**PUBLIC HEARING
88 PARK STREET (Unit #35)**

Application For: Certificate of Appropriateness - Construction of Rear Roof Deck

HISTORIC PRESERVATION
APPLICATION FOR CERTIFICATE OF APPROPRIATENESS

Re: Rear Deck Construction

DESCRIPTION OF PROJECT

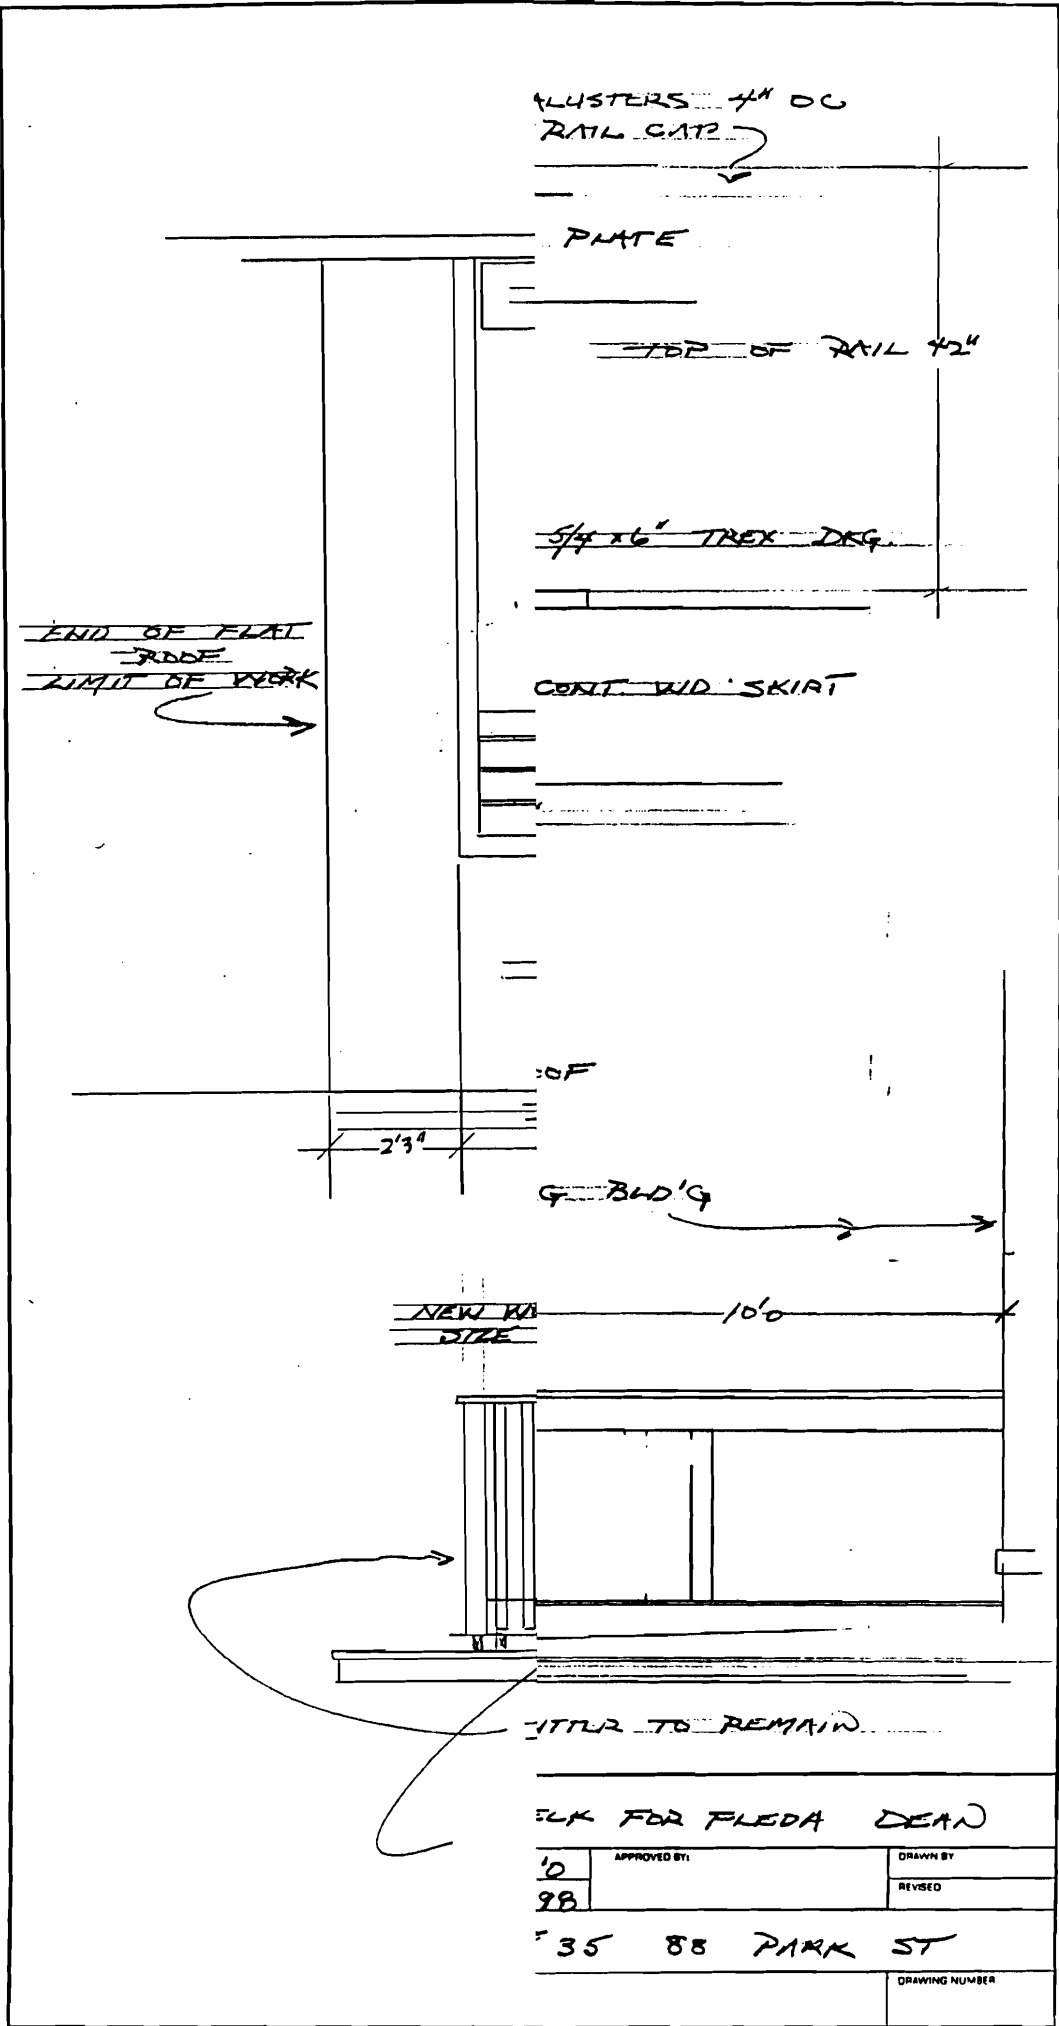
1. That the surrounding deck balustrade feature both a rail and subrail and that the top rail be chamfered so as to prevent warping or cupping.
